DRIVESHAFT INSPECTION TOLERANCE

When we (the FMTV team) at TACOM LCMC published Maintenance Action Message (MAM) 09-018, *PS* wrote about it on Page 16 of *PS* 681 (Aug 09). However, the PMCS driveshaft inspection tolerances given in that maintenance message were wrong! They're called out in reverse.

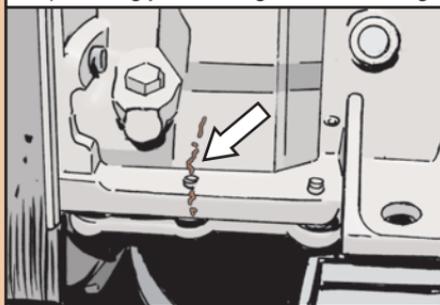
That's why the paragraph found in the last bullet of that *PS* article should be corrected to say:

Perform the driveshaft hinging inspection. No more than 0.020 inch of play is allowed. Also, perform the radial end play inspection. No more than 0.006 inch of play is allowed. After the inspection is done, lube your truck's driveshaft universal joints.
